Planning Commission Staff Report

Subject: Abandonment Case Number: AB16-005
Applicant(s): Jerry Havniar
Agenda Item Number: 9C
Summary: Abandon a 4-foot wide strip of right-of-way in front of 70 Sunbeam Lane.
Recommendation: Denial
Prepared by: Eva M. Krause - AICP, Planner
Washoe County Community Services Department
Planning and Development Division
Phone: 775.328.3628
E-Mail: ekrause@washoecounty.us

Abandonment Case Number AB16-005 (Havniar) – Hearing, discussion, and possible action to approve the abandonment of a 4 foot wide strip of public right-of-way (305.5 sq. ft.) along the front (southern) property line of 70 Sunbeam Lane.

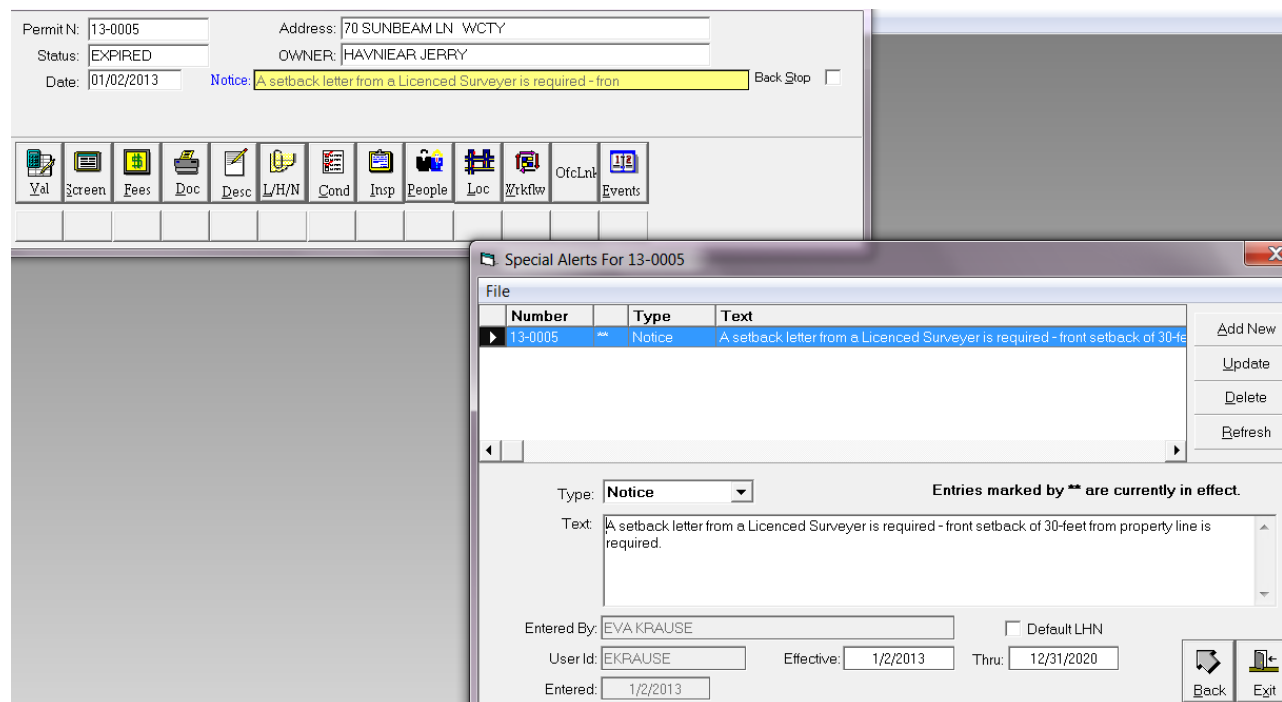
The applicant owns a single family residence that was built in 1985. In 2013, the applicant hired Priceless Construction to build a garage addition on the front of the residence. Planning Staff reviewed the building application at that time. The site plan submitted with the application indicated that the proposed garage addition conformed to the required 30 foot front yard setback, but based on Washoe County’s Geographic Information System (GIS) maps, staff questioned the accuracy of the site plan. Staff contacted Priceless Construction to discuss the apparent discrepancy, but was told by the contractor that his drawings were correct. Staff informed the contractor that a footing inspection would be required to verify the structure is setback 30 feet from the property line.

When the County Building Inspector asked the contractor for the footing survey before final inspection of the garage, the contractor acknowledged that the structure did not meet the setback. The contractor called planning staff to discuss the option of getting a variance. Staff explained the property owner could apply for a variance, but because this was a self-induced condition and not a hardship of the land, staff would not recommend approval of the variance.

Screen Shot from Permits Plus for building permit 13-0005

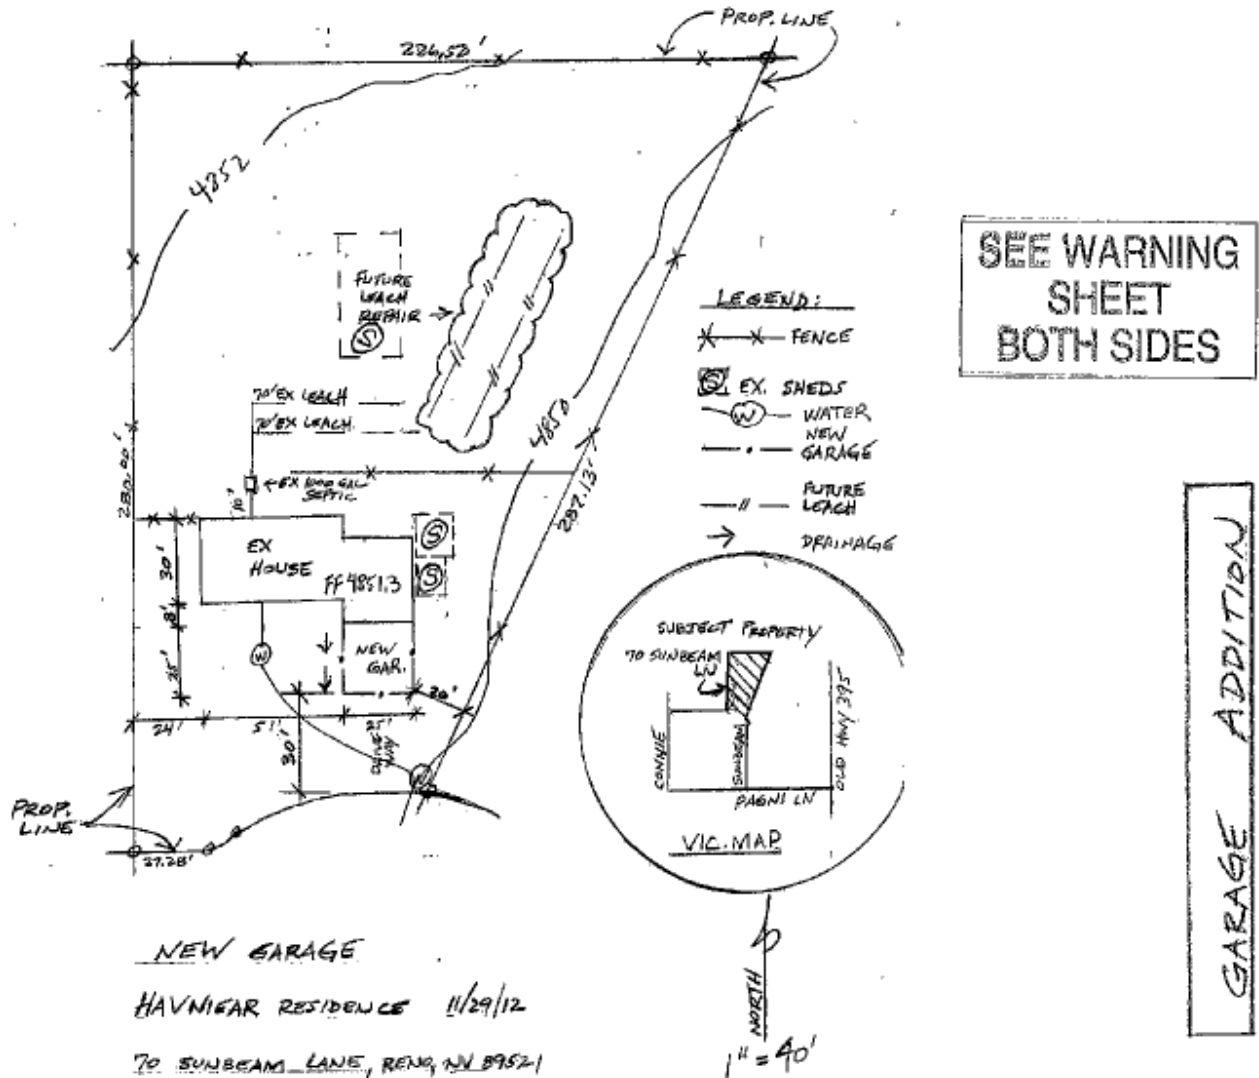
The end result was that the contractor did not obtain a final inspection/approval of the garage addition. The property owner was not aware that the garage had not been finalized and paid the contractor for his work. When the building permit expired, the building department red tagged the structure and ordered the property owner to correct the condition or remove the addition.
